**MEETING OF THE  
CONSERVANCY SCENIC CORRIDOR COMMITTEE  
Wednesday, August 19, 2020 at 7:00  
Village Hall, 3110 RFD, Old McHenry Road, Long Grove, Illinois**

**V. NEW APPLICATIONS:** CSCC 20-01; Consideration of the preliminary plans for the subdivision of property to be known as the "Phillip Estates" PUD (formerly Canterbury Park) and within the R-2 Residential District (reclassification required), including the location of Conservancy District Boundaries & pathways within Scenic Corridors & Conservancy Easements and native plantings on property commonly known as vacant property on the south side of Cuba Road submitted by the Phillip Estates LLC.

**RE:** August 19<sup>th</sup> - MEETING ISSUE REVIEW

RE: Philip Estates Subdivision  
Preliminary Landscape/Existing Tree Survey & Preservation Plan Review

**1 PRELIMINARY LANDSCAPE PLAN -**  
 Scale: 1"=80'

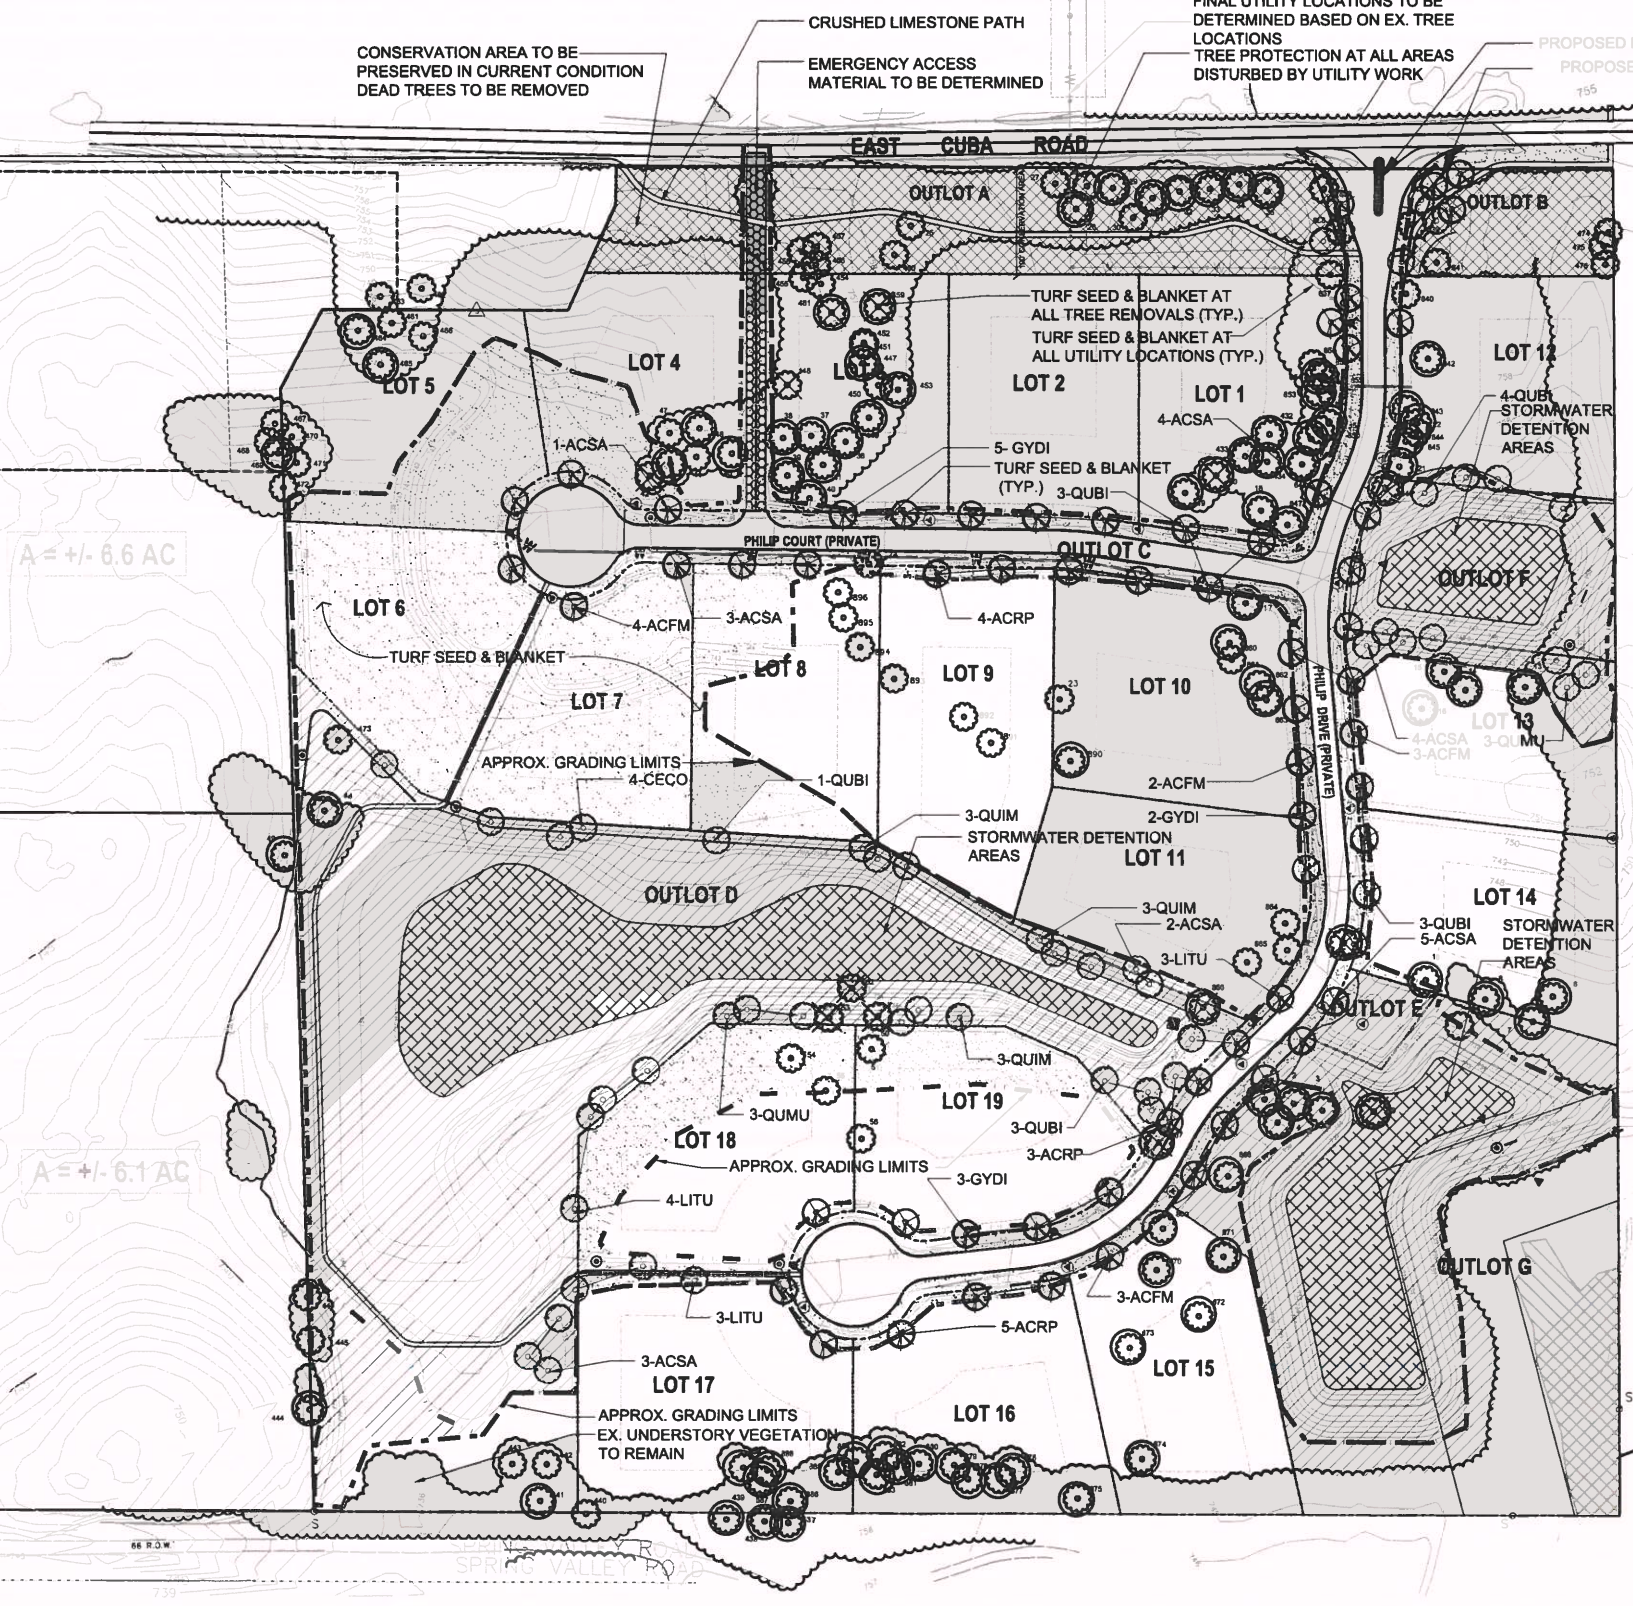
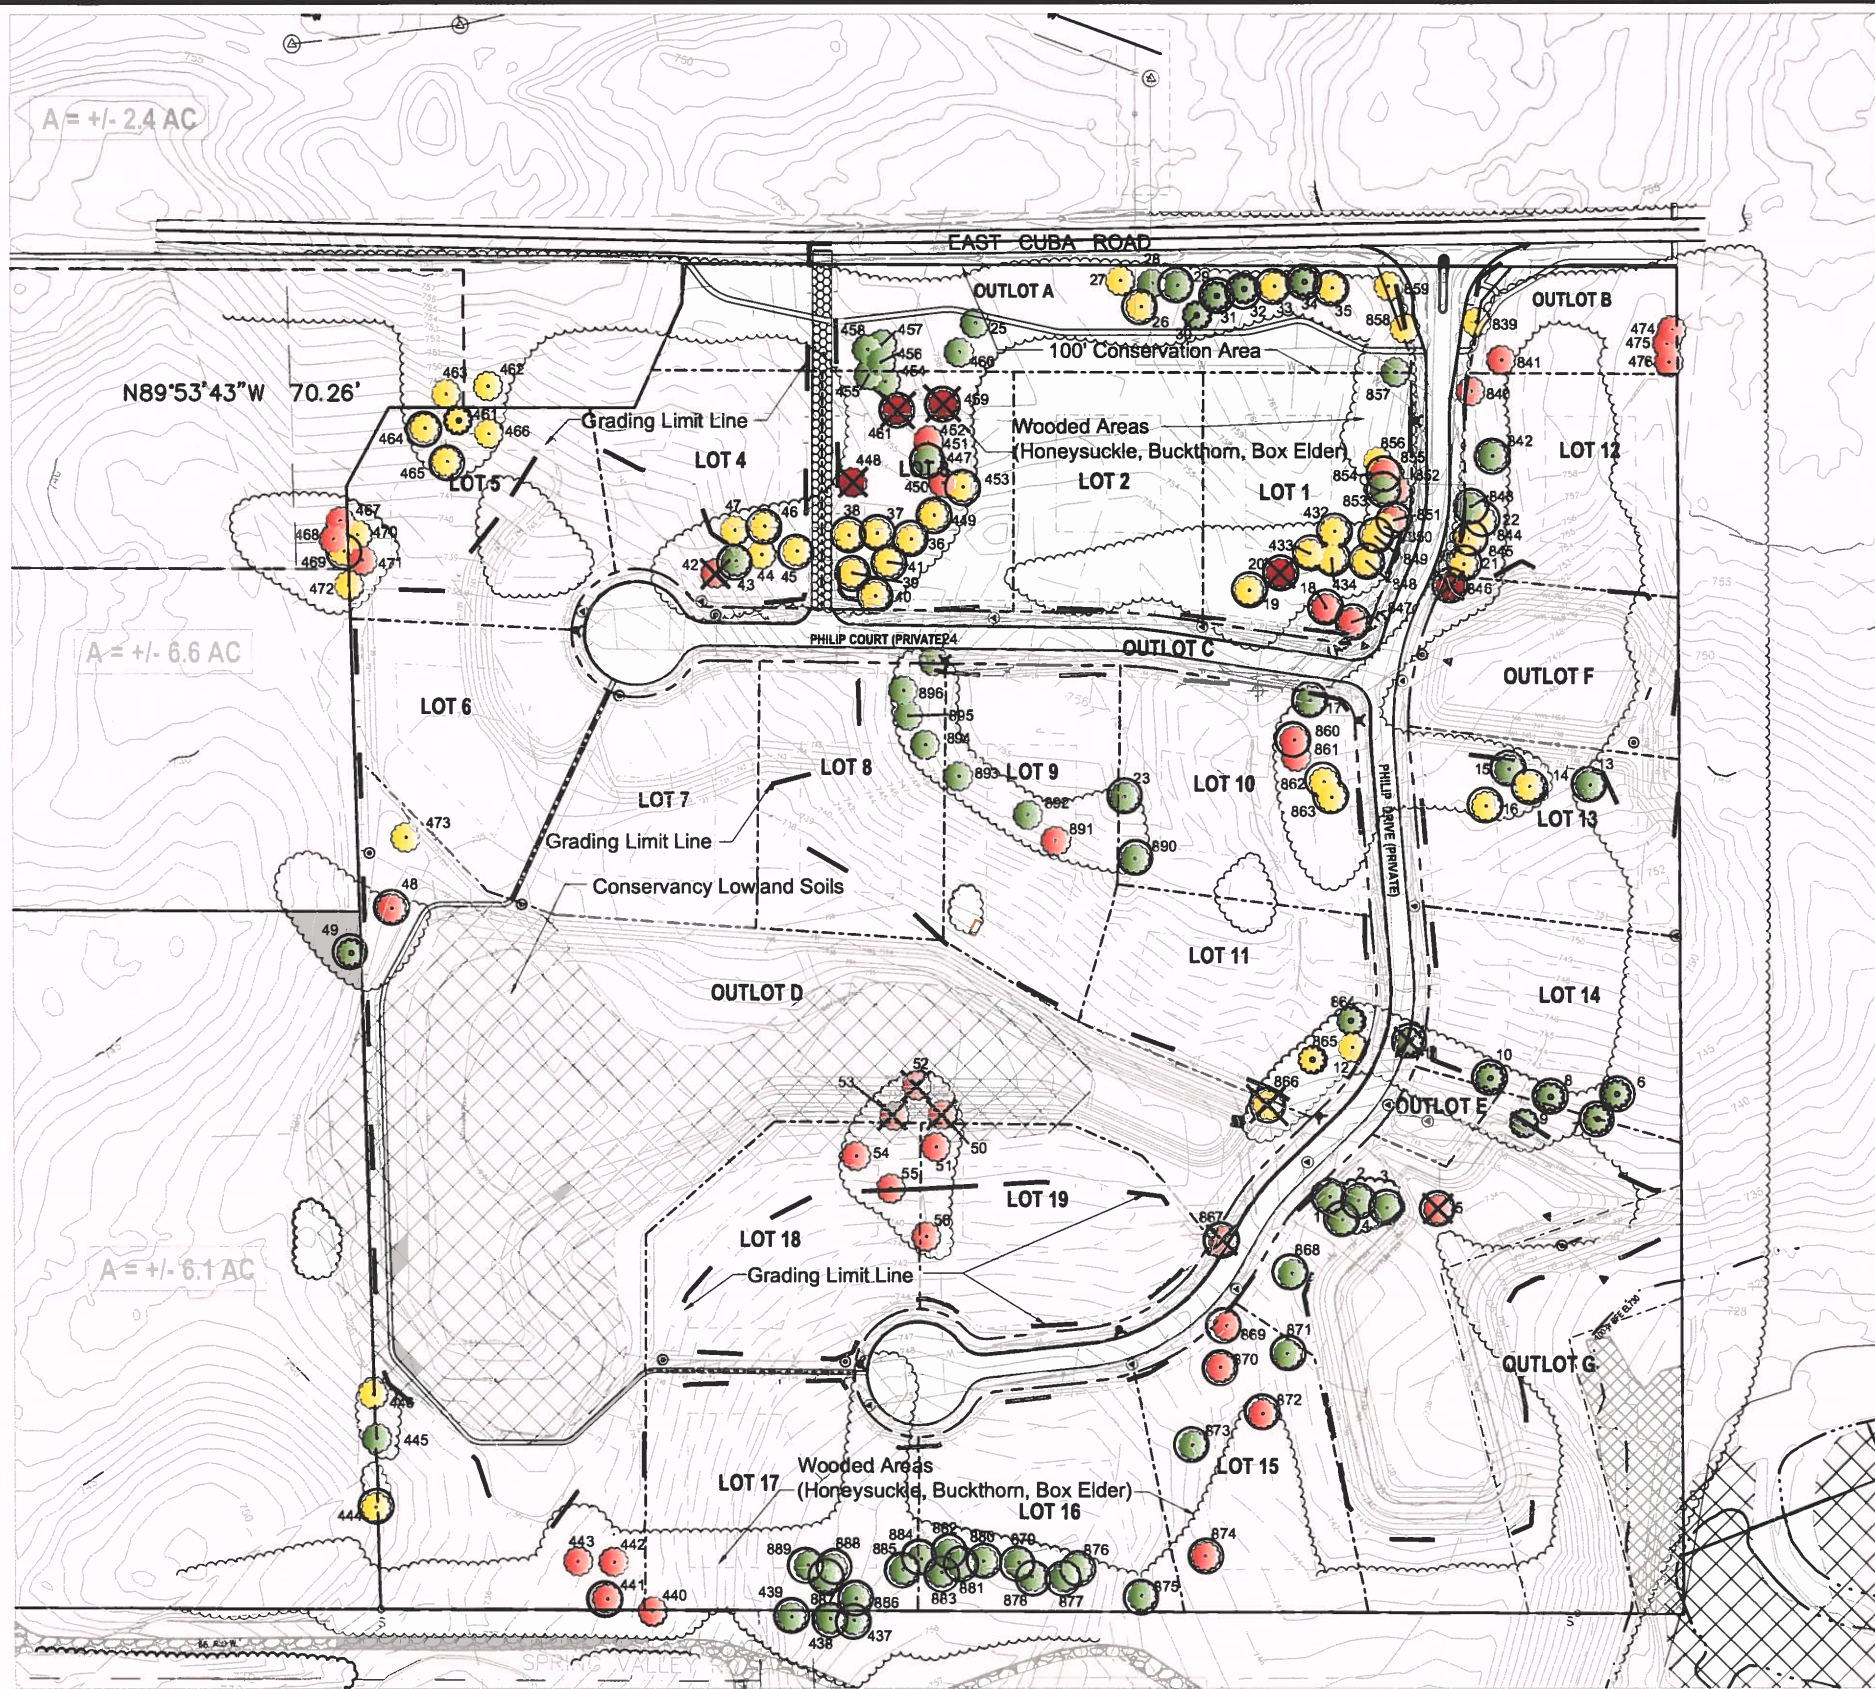
The petitioner proposes a 100' Scenic Corridor Easement that is consistent with village code requirements. Based upon the submitted plans it appears that existing vegetation will largely maintained in the corridor. Plantings are proposed around the entrance to the subdivision and should be reviewed by the CSCC.

The CSCC should review the proposed plantings in the detention and conservancy areas and determine suitability (See Preliminary Landscape Plans “LP-1” & “LP-2”).

- The comments of the arborist should be incorporated into any recommendations of the CSCC as applicable.
- The CSCC should review the proposed plantings in the detention and conservancy and scenic corridor areas and determine suitability.
- Pathways will be integrated within the development and the modification as suggested should be considered. The CSCC should review and make recommendations on the appropriateness of the pathway system as it relates to the scenic corridor and conservancy easements.
